SUBJECT: University of Illinois - Willard Airport
Savoy, Illinois
Champaign County
Illinois Project Number: CMI-4606
Contract No. UN058
Item No. 02A, January 17, 2020 Letting
Addendum C

NOTICE TO PROSPECTIVE BIDDERS

CONSTRUCT TAXIWAY A5

CP301
SHEET 17 OF 39

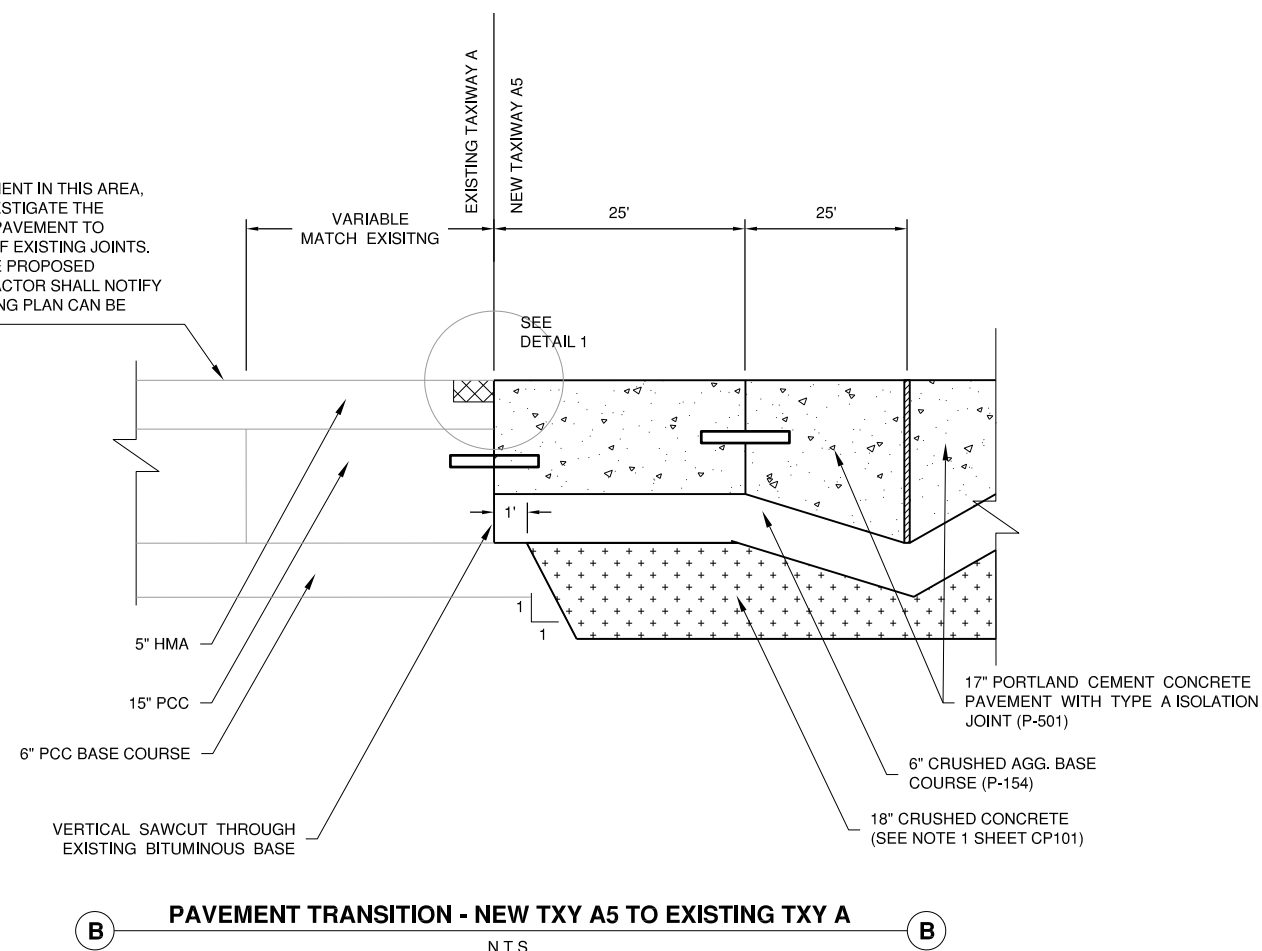
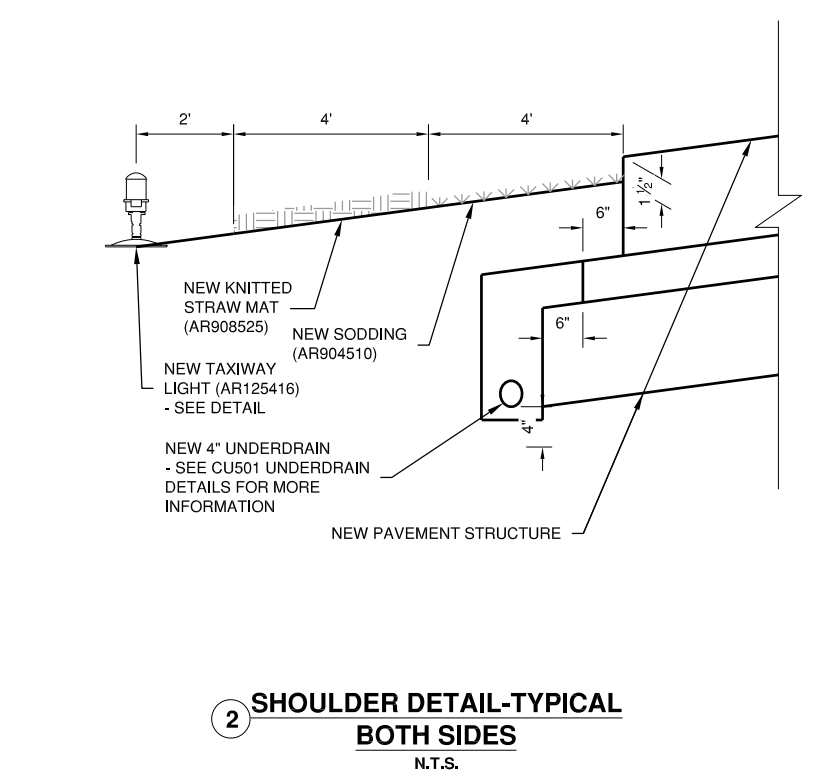
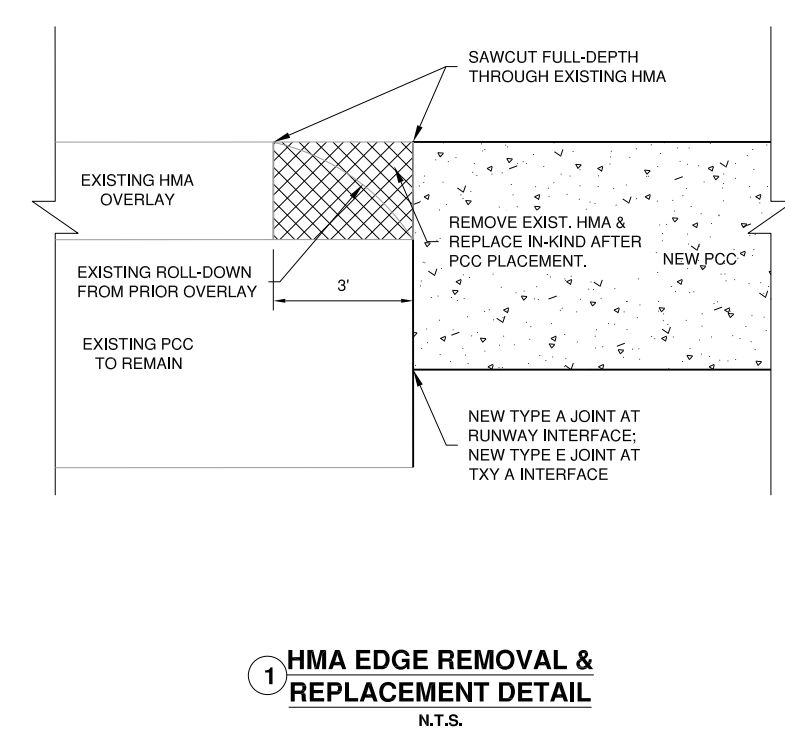
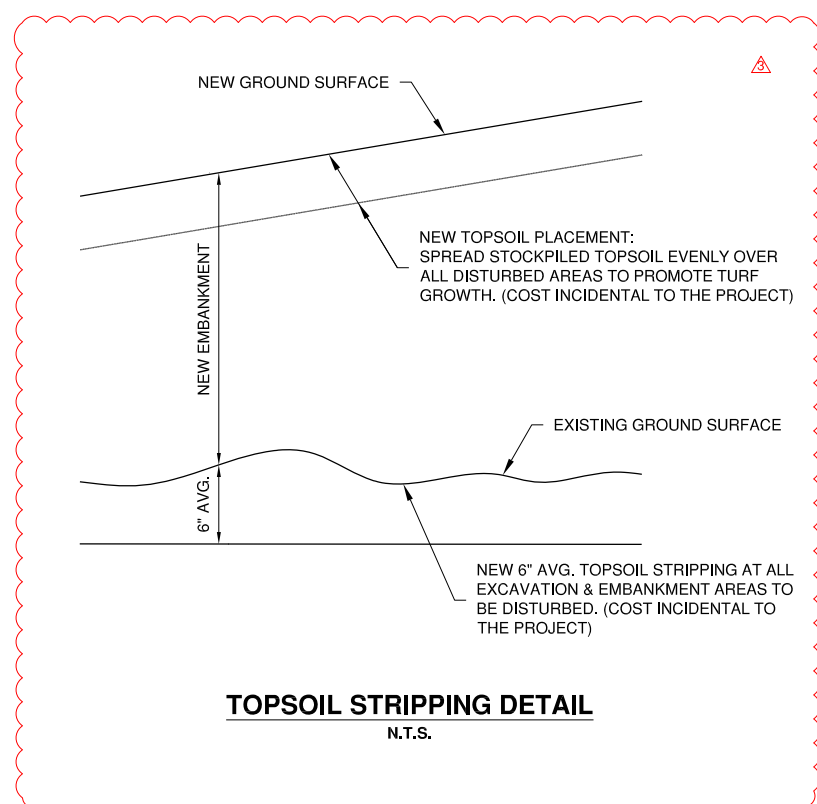
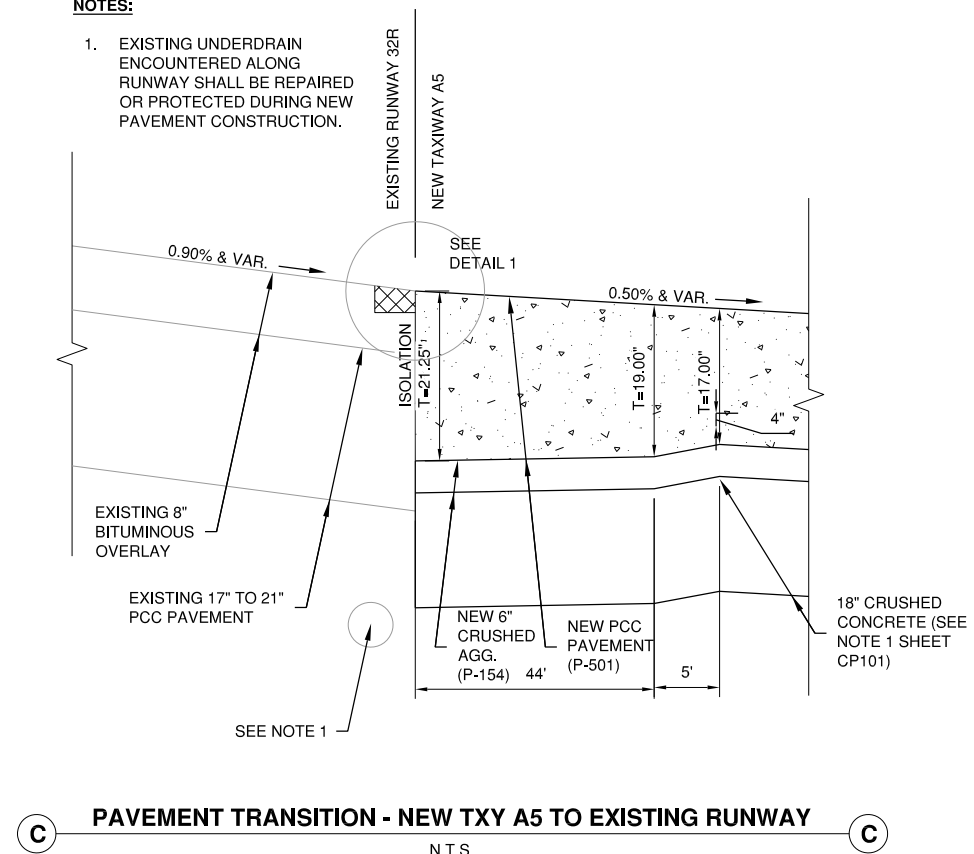
Provide clarity on the topsoil requirement – Update to Specification 905-3.1 and Sheet CP301.

1. Add topsoil stripping detail for clarity.

DPA 1/10/20 ADDED TOPSOIL DETAIL

CS702A

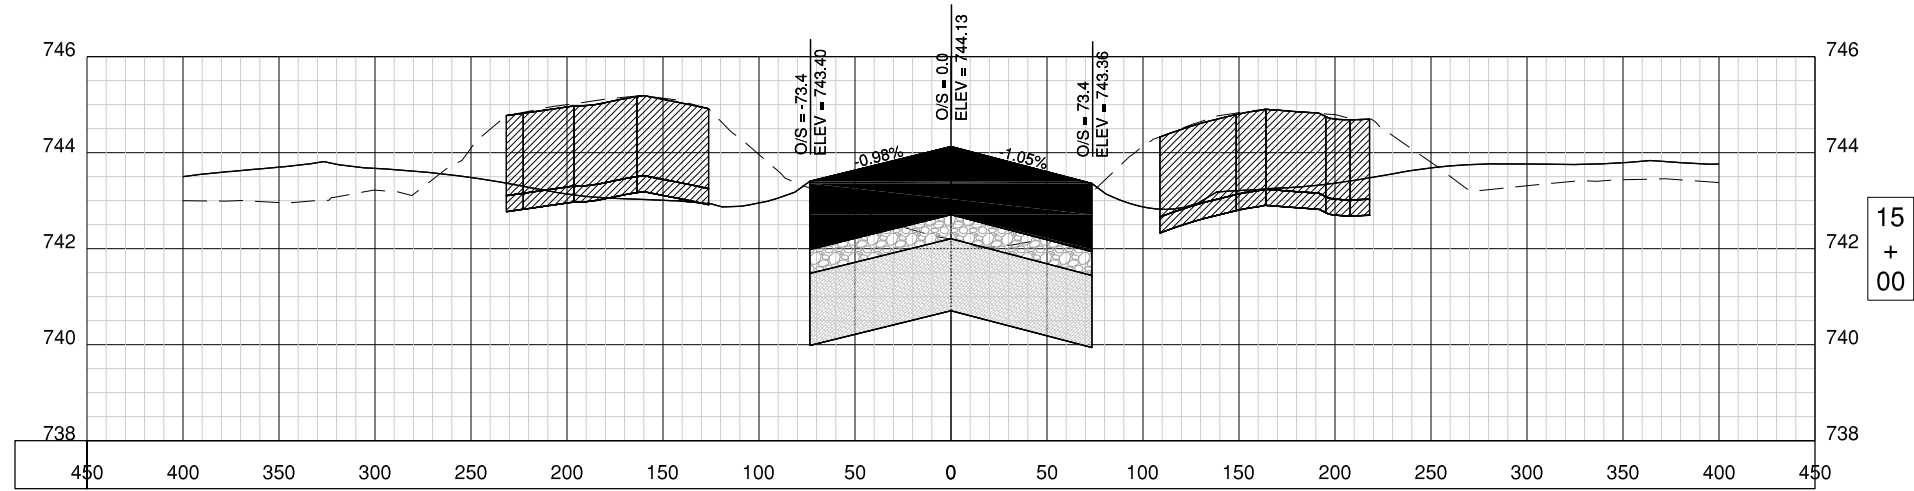
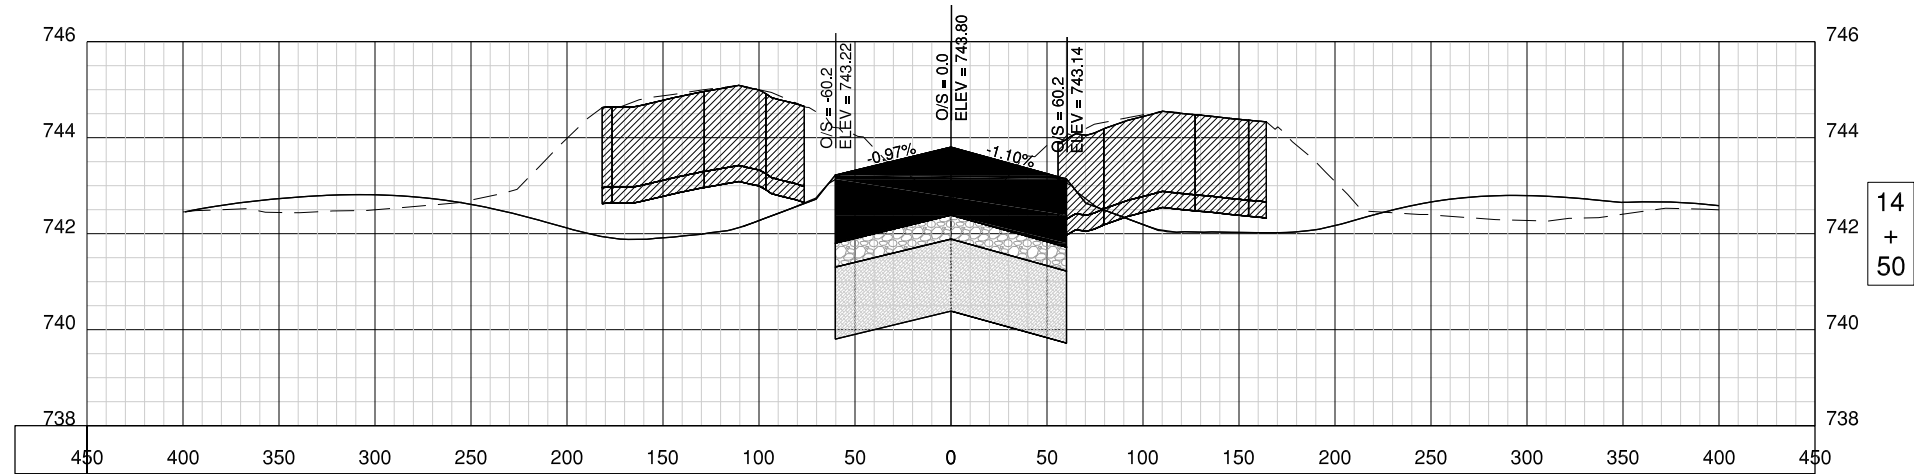
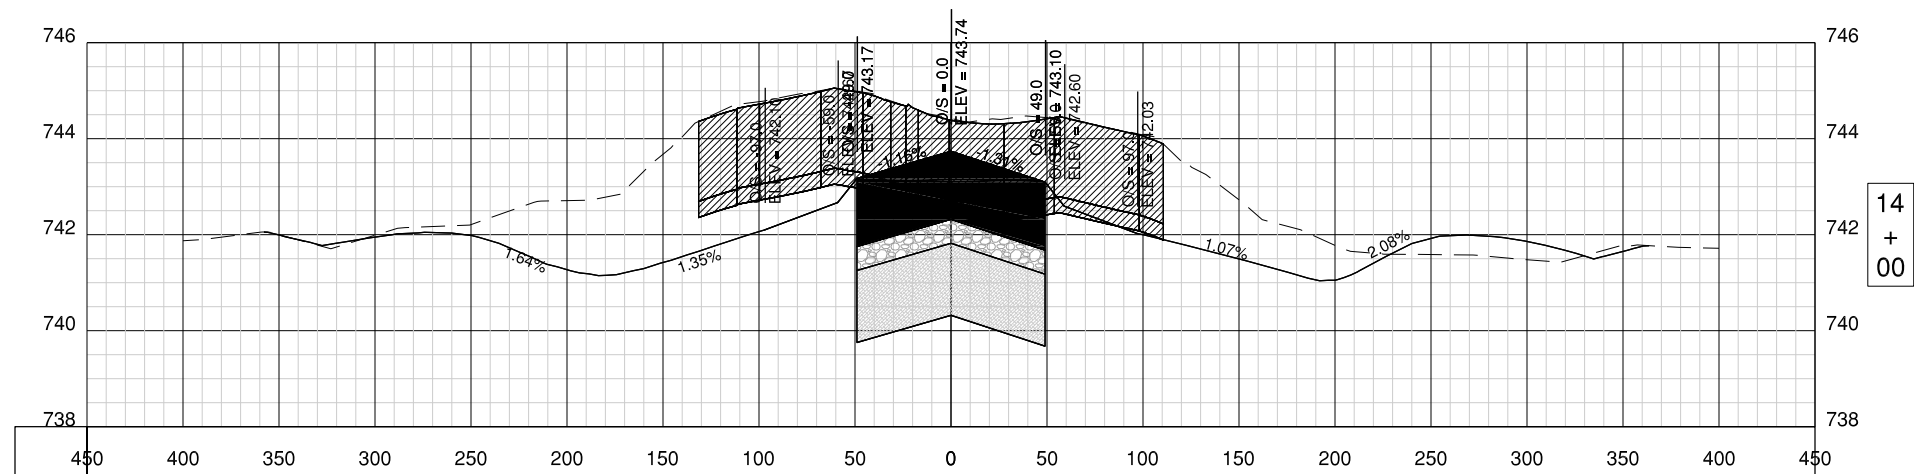
Contractor's Request for additional Cross Section – Sheet CS702A added.

1. Add cross section at station 15+00 for clarity.
